AXOD/AXODE (AX4S) UPDATE HANDBOOK

*Updated
October, 2002*

Since the introduction of the Ford AXOD transaxle in model year 1986, there have been many major engineering design changes that have affected many of the parts used in the AXOD transaxle. This version of the AXOD "Update Handbook" begins with the 1986 model year and will explain each change, the parts affected by the change, and any parts interchange problems created by the change. This booklet is an updated version of the original.

Figure 64

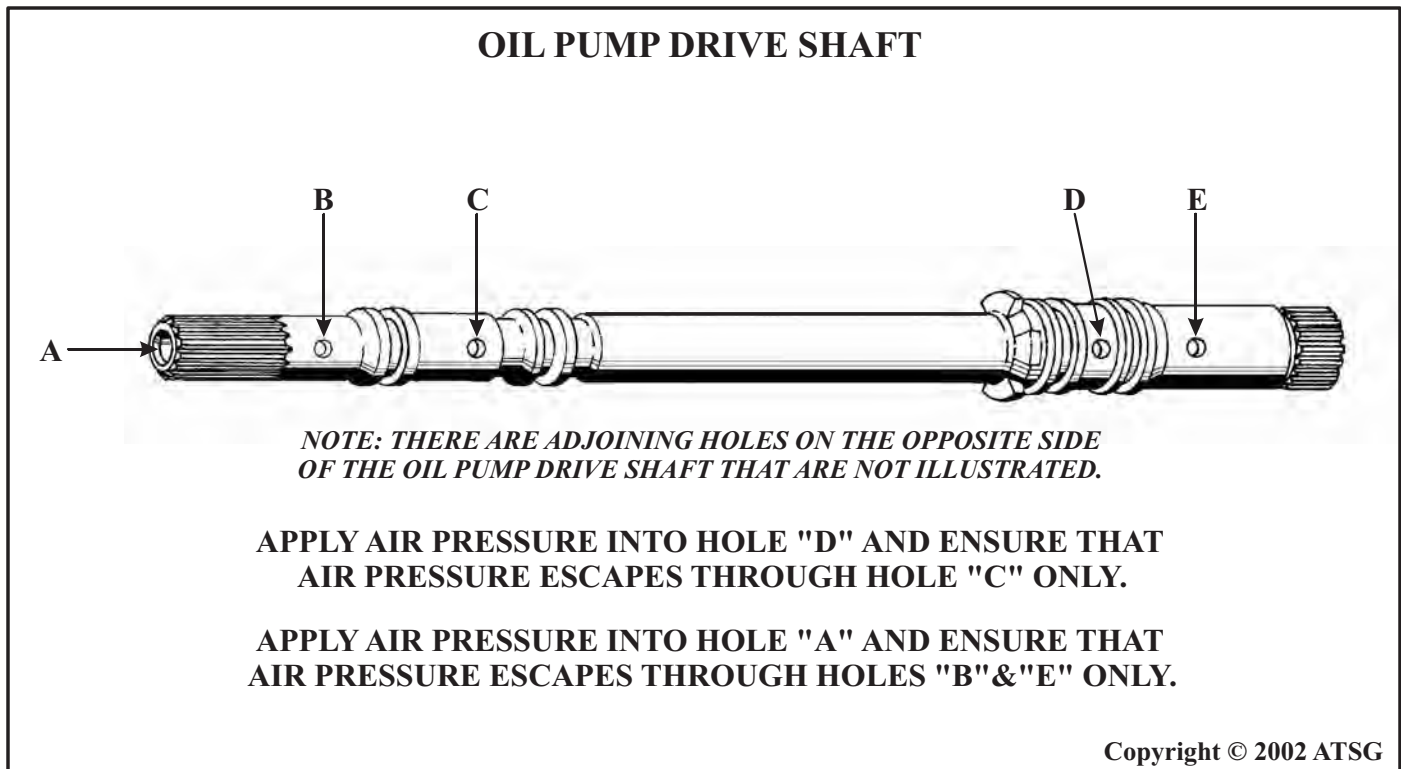
CORRECTION: Refer to Figure 64 to *check* the Oil Pump Drive Shaft, and clean or replace as necessary.

Figure 66

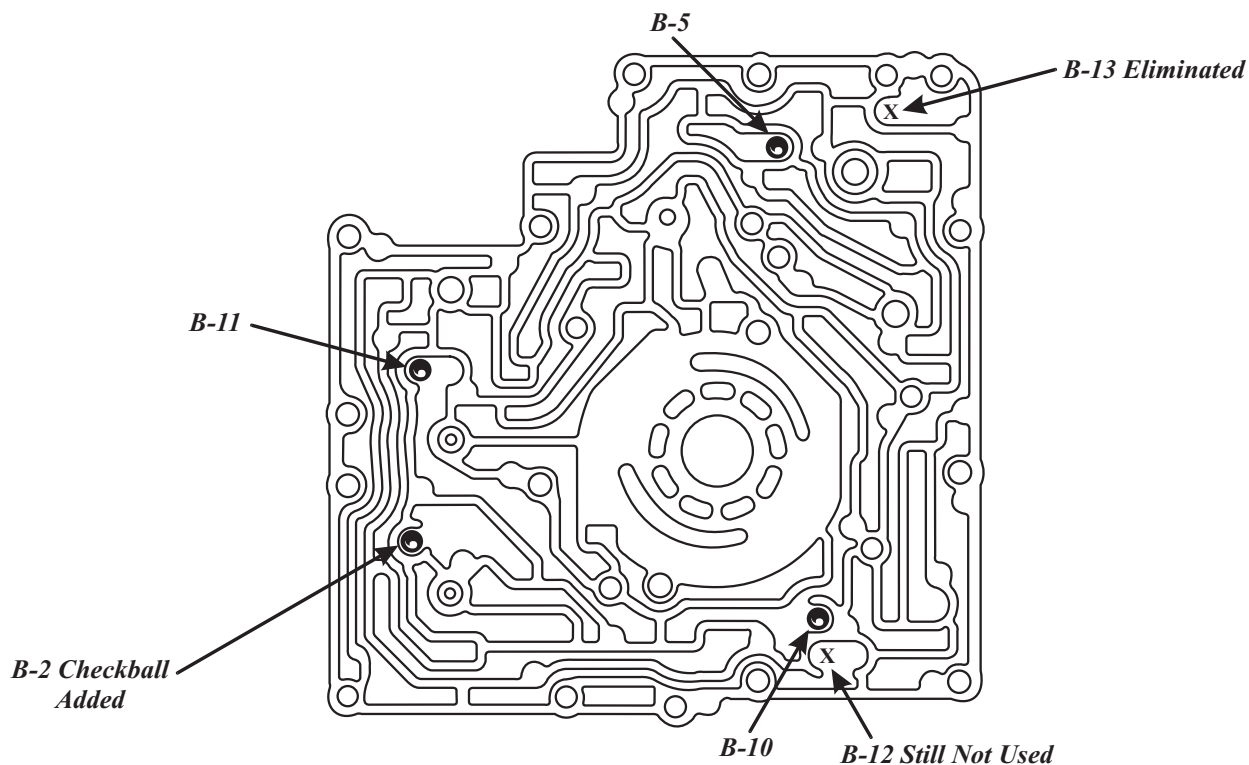
1992-1998 Only - Uses 4 checkballs but in different locations, as shown in Figure 66. B-13 checkball was eliminated and B-2 checkball was added.

1999-2002 Only - Uses 3 checkballs in the locations shown in Figure 66. B-5 checkball was eliminated.

Figure 75

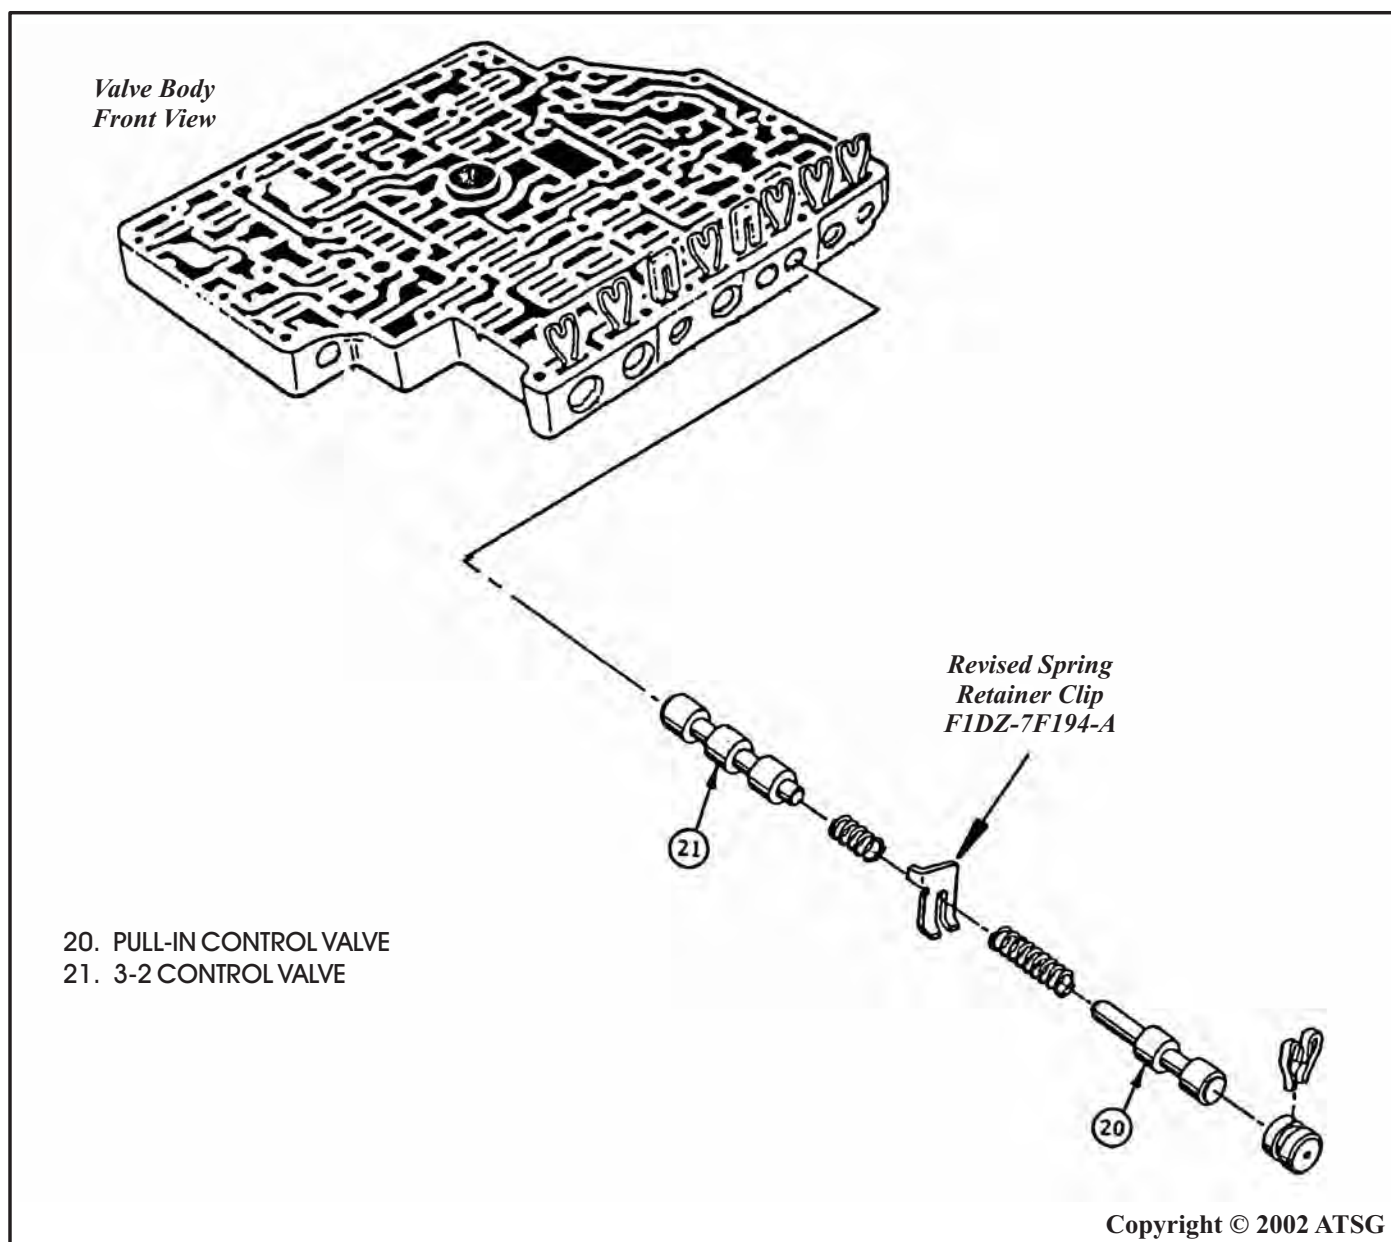
CAUSE: The cause may be, a broken spring retainer clip between the pull-in control valve spring and the 3-2 control valve spring, as shown in Figure 75.

CORRECTION: Replace the spring retainer clip with OEM part number F1DZ-7F194-A, as shown in Figure 75.

Figure 83

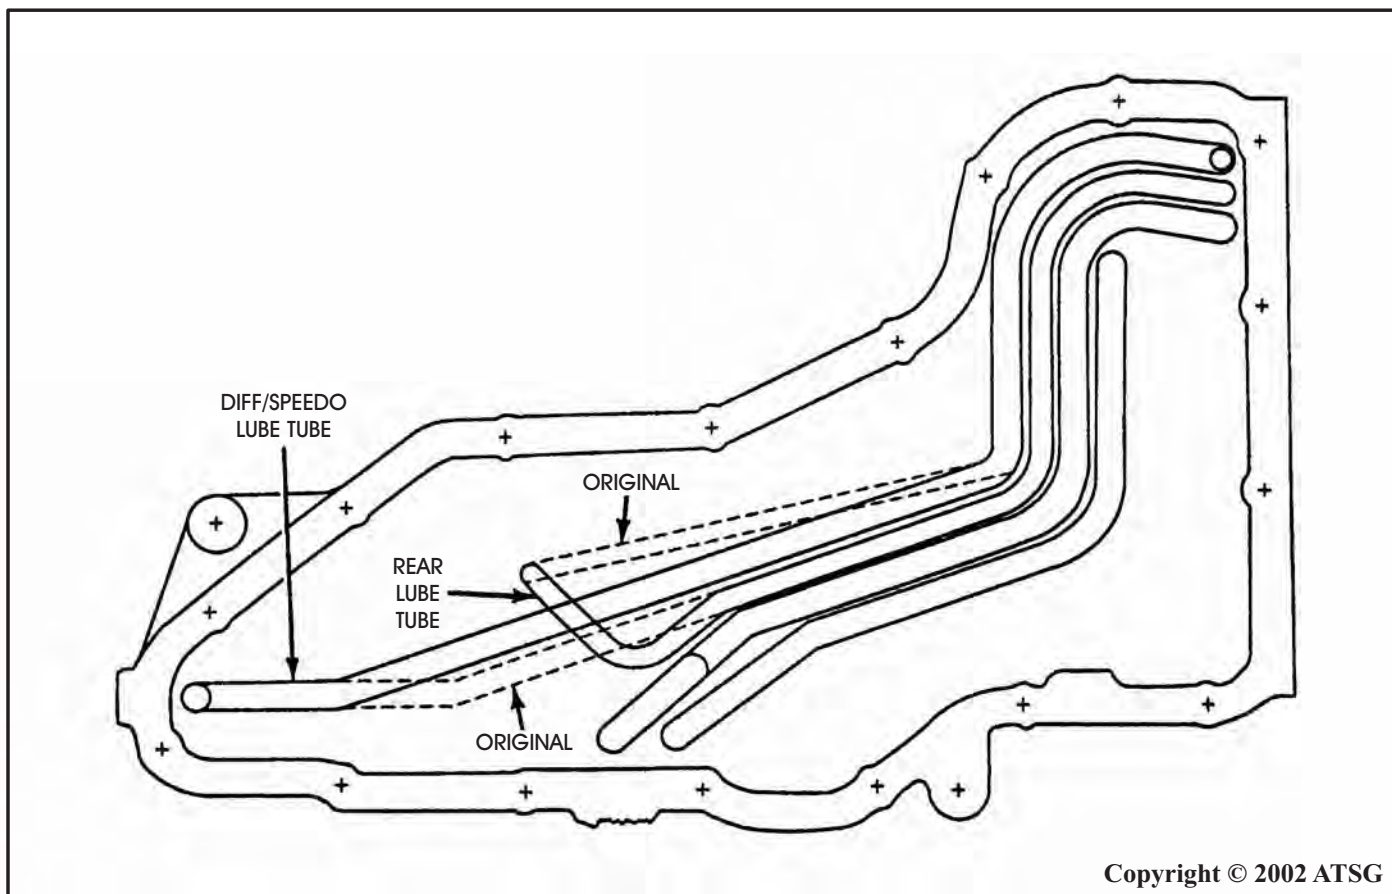
COMPLAINT: Front planetary and gear train failure with no visible root cause.

CAUSE: The cause may be, a limited volume of lube oil to the front planetary due to hydraulic control system demands.

CORRECTION: Install a new design "Cross-over" rear lube tube and a new design Differential/Speedo lube tube, that will increase the volume of lube oil to the front planetary system, as shown in Figure 83. This requires the rear lube tube to "Cross-over" the differential and speedo lube tube, as shown in Figure 83.

Figure 85

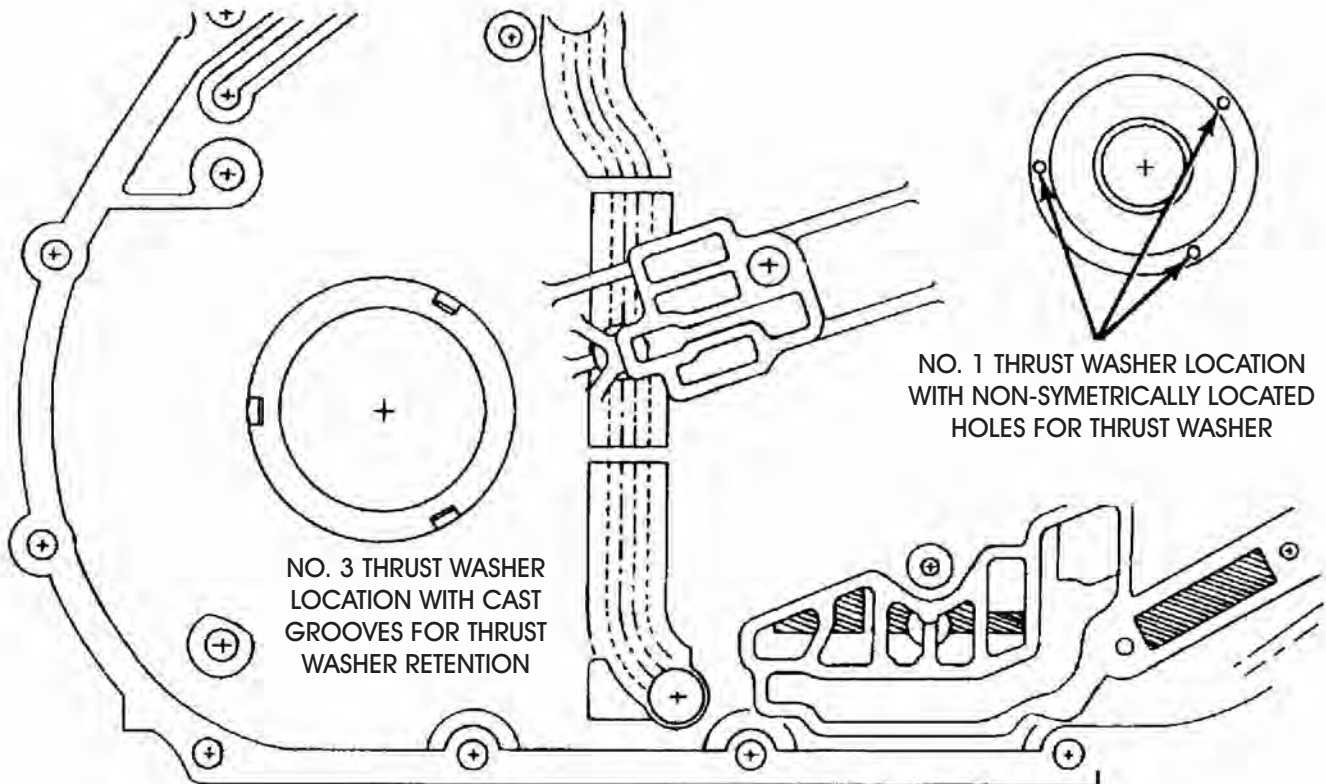
- (3) CHAIN COVER - New design will accept either the previous bronze No. 3 thrust washer with the tangs on outside diameter, or the new design Black plastic No. 3 thrust washer with the 3 symmetrically located tabs, as shown in Figure 86.
The previous design Chain Cover will accept *only* the bronze No. 3 thrust washer with the tangs on the outside diameter, as shown in Figure 85.
The new design Chain Cover will accept *only* the new design No. 1 thrust washer with 3 symmetrically located tabs, as shown in Figure 86.
The previous design Chain Cover will accept *only* the previous design No. 1 thrust washer with 3 non-symmetrically located tabs, as shown in Figure 85.

Figure 89

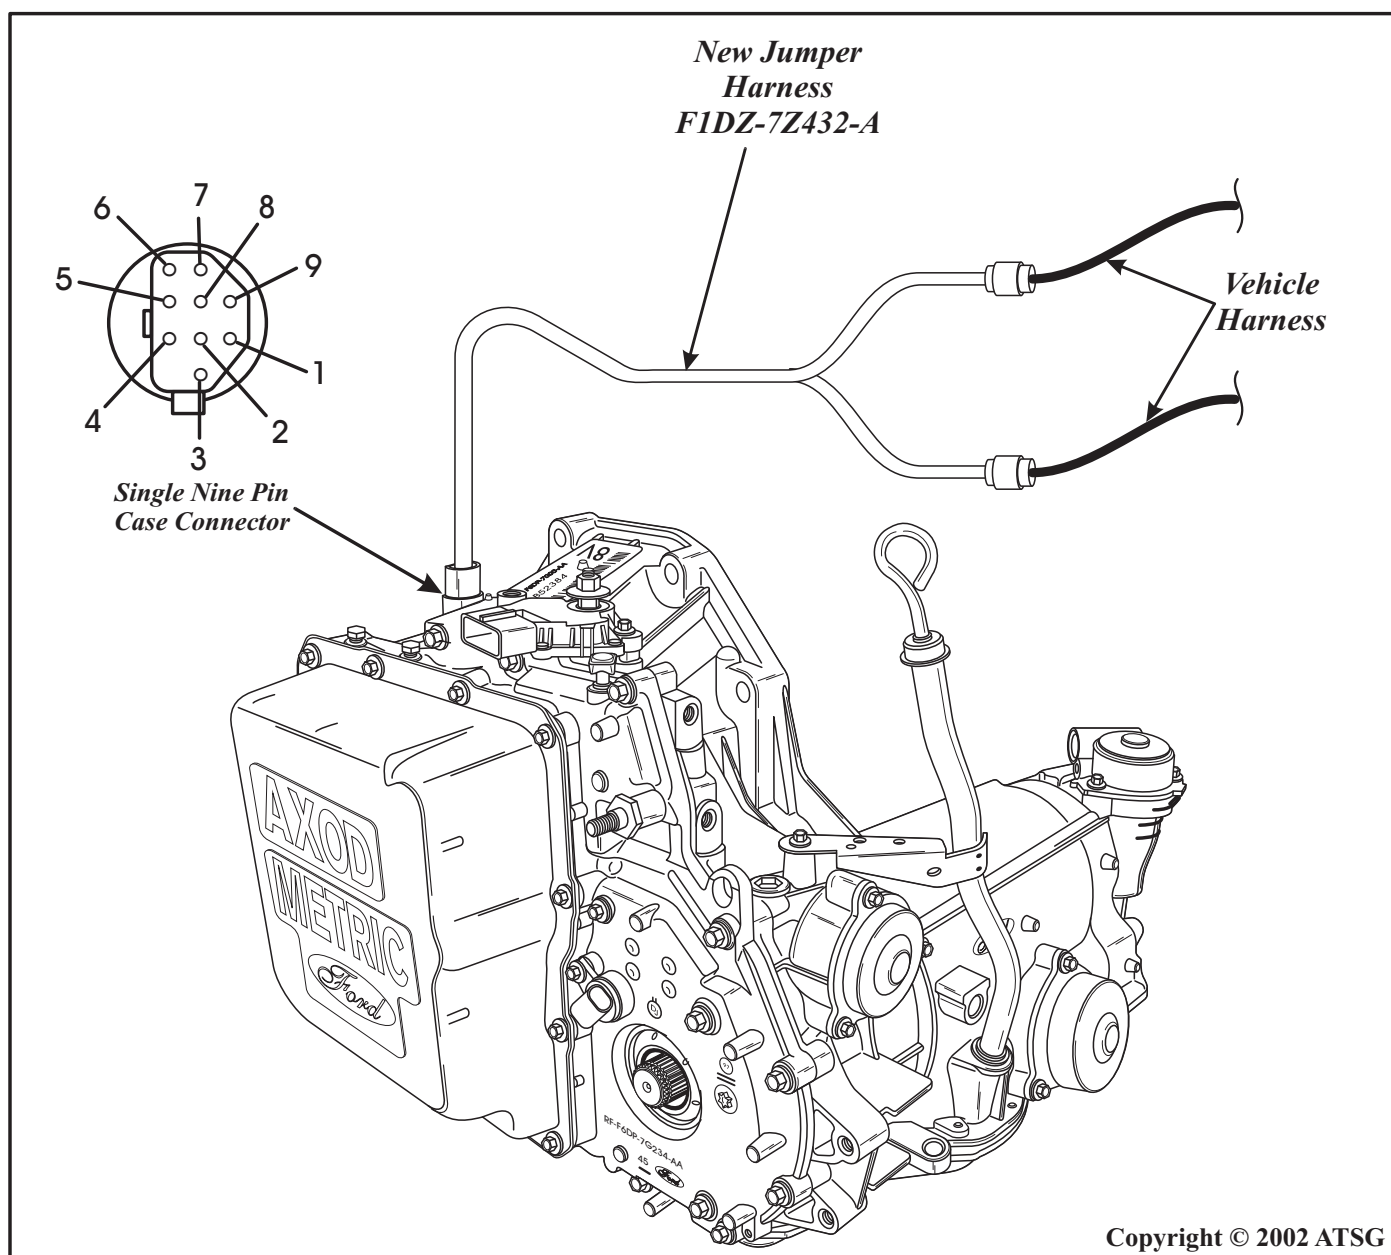
If service requires replacement of the chain cover on a 1991 or 1992 AXODE transaxle, it must be replaced with a 1993 design level AXODE chain cover assembly kit. The 1993-Up design level chain cover has only one nine pin external electrical connector located at the top of the transaxle as shown in Figure 89, and the previous side connector, as shown in Figure 88, has been eliminated. This requires a new "Y" harness, which is included in the service package "Kit", to make it compatible with 91-92 vehicles. The new design "Y" harness is also illustrated in Figure 89.

Figure 90

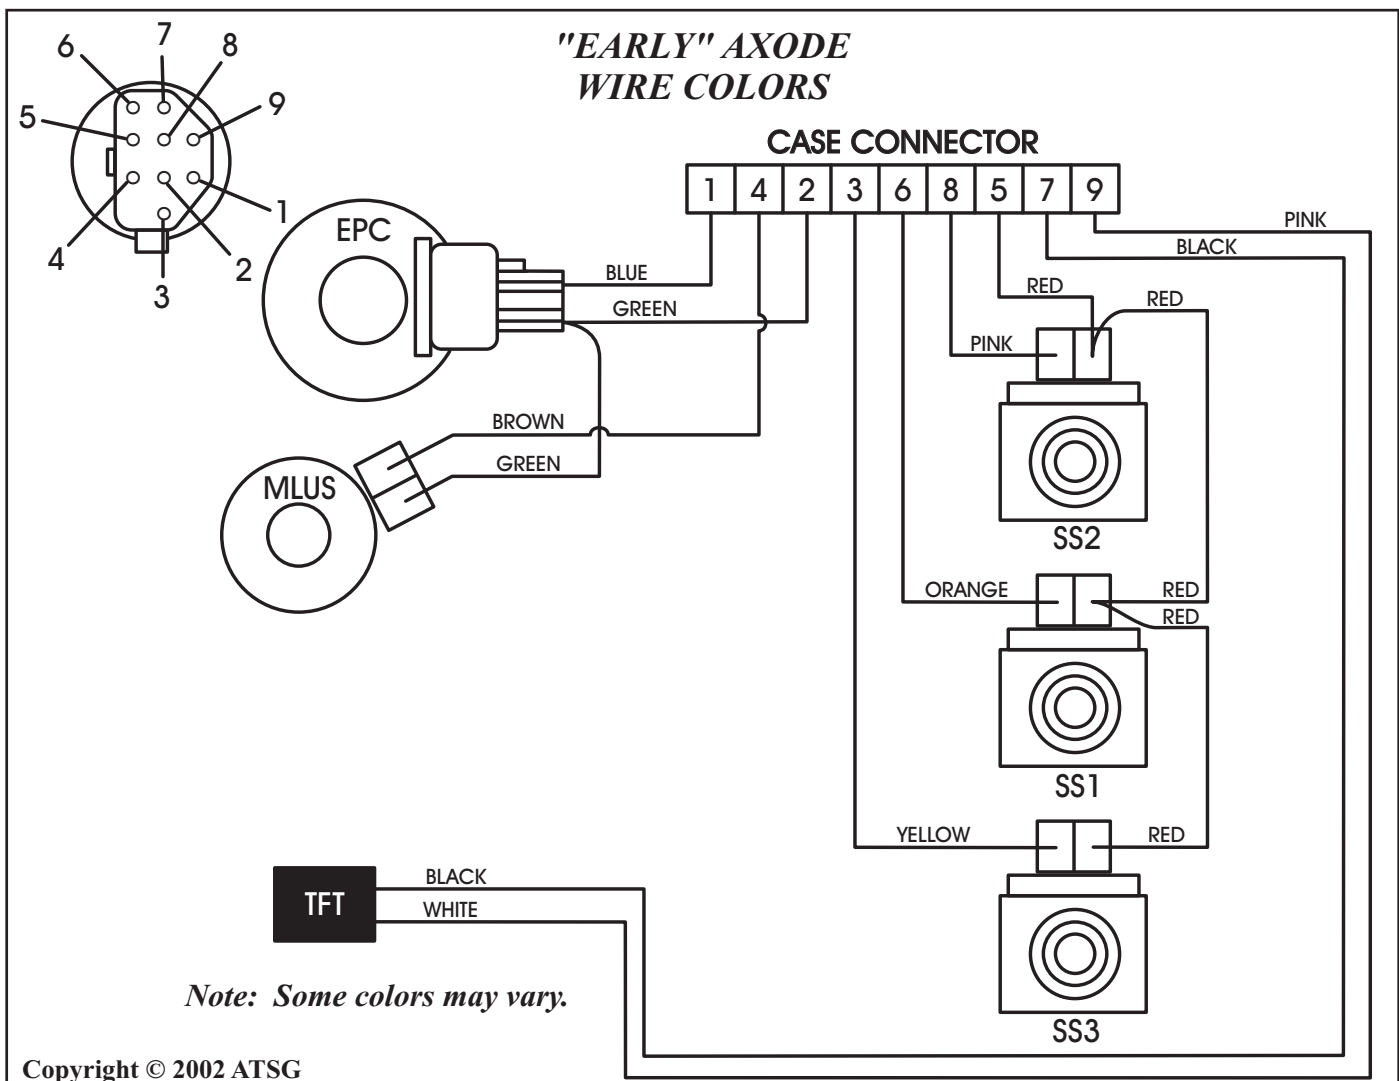
CORRECTION: Connect the internal wiring harness connectors to their proper solenoids, *using the wire colors*, as shown in Figure 90 and 91. Proper connection of solenoids can also be verified externally through the case connector using the Ohms chart in Figure 91.
